Design Review Report – Item 1

Local government:	City of Stirling	
Item no.:	Item 1 – PDA21/0184 – 315 & 319 Harborne Street Glendalough – Pre Development Application – Grouped Dwelling	
Chairperson:	Emma Williamson	
Panel members:	Philip Gresley Michael Murphy Tony Blackwell John Taylor	Deputy Chairperson
Local government officers:	Amanda Sheers Dean Williams Cameron Howell Van Phan Simone Palmer	Manager Development Services Acting Coordinator Planning Senior Planning Officer Planning Officer DRP Support Officer
Observers	Vicky Coleman June Liaw Sarah Truong Michael Italiano Michael Ball Karina Bowater Taylor Wilson	Senior Planning Officer Planning Officer Planning Officer Planning Officer Planning Officer Senior Planning Officer Administration Officer
Date:	11 November 2021	Time: 2pm
Venue:	City of Stirling, 25 Cedric Street Stirling, Parmelia Room

Design quality evaluation Item 1 – PDA21/0184 – 315 & 319 Harborne Street Glendalough – Pre Development Advice - Grouped Dwelling DRP Meeting – Thursday 11 November 2021	
	<i>Design Principle satisfied</i>
	<i>Design Principle pending further attention</i>
	<i>Design Principle not satisfied</i>
Principle 1 Context and character	<i>Goo

1 GROUND FLOOR / MASTERPLAN

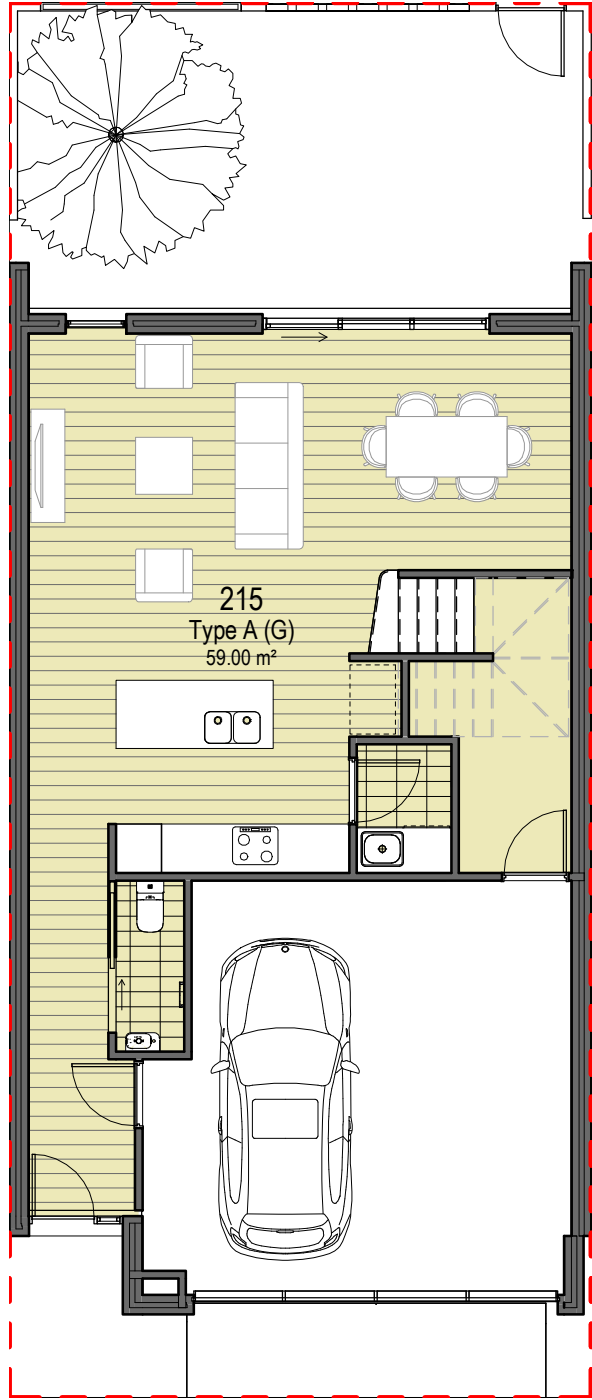
masterplan and layouts to the Type G townhouse unit. For the eastern edge, a compliant R60 primary street setback to Harborne Street is 2m. Due to the overhead powerlines, this has been increased to 2.3m, with a further 0.3m added for fenestration, level changes and architectural details – giving an increased street setback of 2.6m. The front garden design and relationship to street has been further developed, including planting and materials. Levels are also proposed to be raised in both locations to give a better relationship between privacy and surveillance. Portions of masonry wall fencing and double glazing are proposed.		
2a. The Panel encouraged the Applicant to make landscaping a higher priority and further develop the landscaping throughout the development. 2c. The Panel stated there is opportunity to better connect to the public open space.	2a. The design team has responded by further developing landscape proposals throughout the development, including soft / species and hard / material selections. A dedicated Landscape Masterplan is now included. 2c. The team has responded by improving the physical and visual connection to the public open space. This has been achieved by enlarging the public access walkway at the western edge, more than doubling the width from 2.6m to 5.3m, and area from 55m² to 113m². The access connection has been strengthened to provide a visual connection, easily visible and legible within the streetscape when traversing the southern road.	2a. It was noted by the Panel that it is important to have mature tree canopy cover included in this proposal and request clarification on the size of trees that will be planted. 2b. The extent of usable deep soil was questioned by the Panel with narrow planting opportunities proposed.

Panel setbacks on the side are not compliant resulting in compromised outdoor areas.	boundary for R60 is 2m, and Western Power require a minimum of 2.3m easement to built form, away from the overhead powerlines. This has been increased to 2.6m to allow for raising of courtyard levels, and to permit additional fenestration and architectural details. Additional design work to improve the front garden courtyard and amenity, including fencing and materials, has also been undertaken. Please see masterplan and Type F layouts within the DRP2 pack. 6d. Side setbacks have been reviewed by the design team's planning consultant (CLE) and by the City for compliance. Items of non-compliance and variations sought will be further identified in planning documents. The design of side setbacks and provision of major openings, balconies and living areas at upper level seeks a balance between activation, elevational treatment, solar protection, passive surveillance and privacy. However it is worth noting that the site planning and masterplan design has been further developed to provide compliant building breaks to allow for high level (minor) openings and cross ventilation. The double frontage units are being further refined and developed to allow for careful activation with control of overlooking. Please see updated masterplan and unit layouts.

TYPE G
SCALE 1 : 100 (A3)

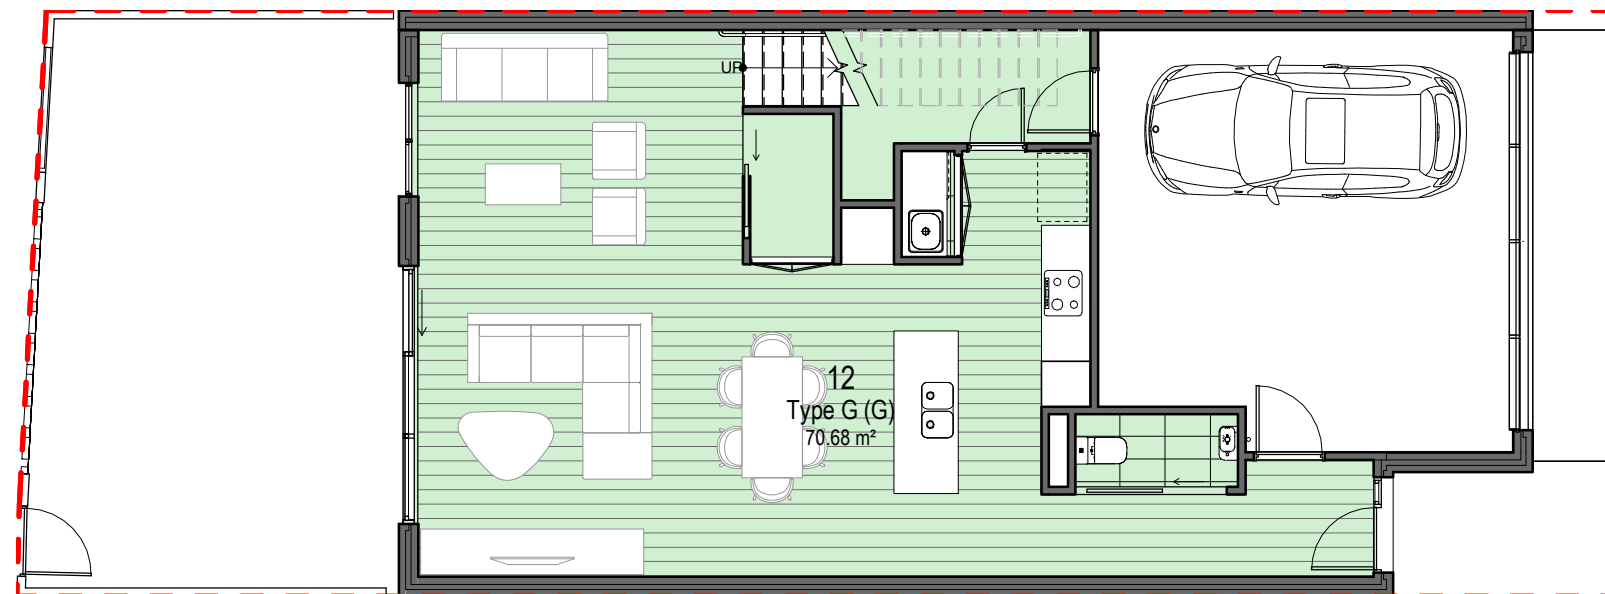
DR1 – DRP Recommendations DRP Meeting – 16/9/2021	DR2 – Applicant Response DRP Meeting – 16/9/2021	DR2 DRP Recommendations DRP Meeting – 11/11/2021	DR2 – Applicant Response DRP Meeting – 11/11/2021
1d. The Panel noted the R60 planning intent is to enable 3 storey high buildings that unlock sufficient open space on a much smaller lot. The size of the private open space in relation to the larger typologies are of a minimum size, a better balance between built and open space is desired. 1e. In relation to the broader context the Panel stated this proposal has not yet responded to the finer grain of the area and there is opportunity for further thought and development. 1f. Comment was made that there is opportunity for improvement around the relationship between the site and the immediate surrounds, particularly in regard to the street context's adjacent building setbacks and the relationship to the public open space to the west.	1d. It is noted that the panel commented that the 2-storey townhouse typology is supported in 3a below. We have responded by improving the balance between built form and open space, with most lots having a private outdoor living area exceeding 3m. The majority of the 105 proposed dwellings (91 no. or 87%) have an outdoor living area which exceeds the minimum dimension of 3m, with only 14 no. (13%) having a minimum dimension of 3m. This 3m minimum depth is also augmented by the 7.7m width, achieving an outdoor living area of 23.1m², exceeding the minimum area of 20m² by more than 15%. Furthermore, the minimum depth of 3m is to a south facing living area, and additionally these dwellings now have access to a north facing outdoor amenity area of 5.4m depth. 1e. We will respond by undertaking a finer grain analysis of the surroundings and broader context. Photographic study to be provided at the DRP2 presentation. 1f. The team has, and will, respond by further refining and improving the relationship to dwellings at the eastern (Harborne) and western (Glendalough Open Space) boundaries. This includes further studies of levels, access arrangements, and fencing materials. For western edge, please see
